Access Compliance Report

Public Rights-of-Way

Intersection ID: 14337	Main Street: BERKELEY_AV	Cross Street: E_MOREHEAD_ST	Location: NE
ADA ID: ABFB9D432983	Ramp Type: PerpDiag	Initial Pass/Fail: Fail	Overall Compliance: No
			Severity Score: 33.75

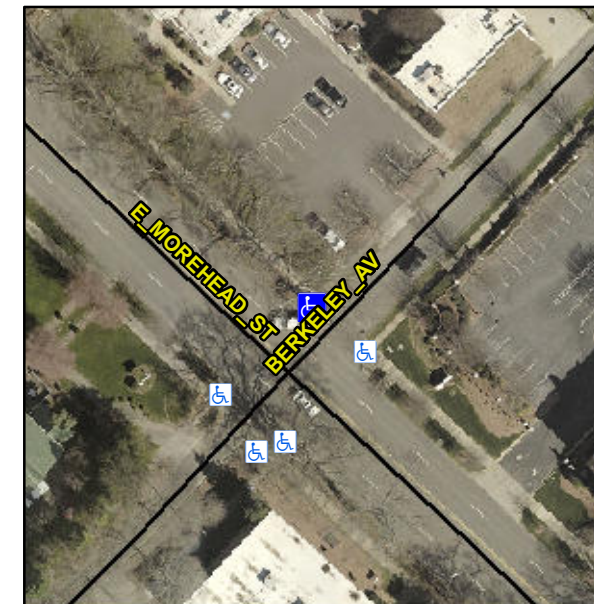
R304.5.1, R304.2.2

Compliance	Description	Data	Compliance	Description	Data
N/A	Ramp Length (in)	87.0	No	Ramp Slope (%)	14.1
No	Ramp Width (in)	47.0	Yes	Ramp XSlope (%)	1.8
N/A	Flare Type LT	N/A	N/A	Flare Type RT	N/A
N/A	Flare Slope LT (%)	N/A	N/A	Flare Slope RT (%)	N/A
N/A	Flare Traversable LT?	N/A	N/A	Flare Traversable RT?	N/A
N/A	Landing Length (in)	N/A	N/A	DWS Provided?	N/A
N/A	Landing Width (in)	N/A	N/A	DWS Contrast?	N/A
N/A	Landing Slope (%)	N/A	N/A	DWS Length (in)	N/A
N/A	Landing X Slope (%)	N/A	N/A	DWS Full Width?	N/A
N/A	Landing Curb? (Y/N)	N/A	N/A	DWS Offset (in)	N/A
N/A	Shared Landing?	N/A			
N/A	Gutter Ponding?	N/A	N/A	Gutter Slope (%)	N/A
N/A	Gutter Lip Ht (in)	N/A	N/A	Gutter X Slope (%)	N/A
N/A	Painted X Walk1?	No	N/A	Painted X Walk2?	No
	X Walk 1 Direction	To SW		X Walk 2 Direction	To SE
N/A	X Walk 1 Width (in)	N/A	N/A	X Walk 2 Width (in)	N/A
	X Walk 1 Slope (%)	2.6		X Walk 2 Slope (%)	0.6
	X Walk 1 X Slope (%)	2.5		X Walk 2 X Slope (%)	1.8

Remove & Replace Curb Ramp With Two New Directional Ramps or Equivalent.
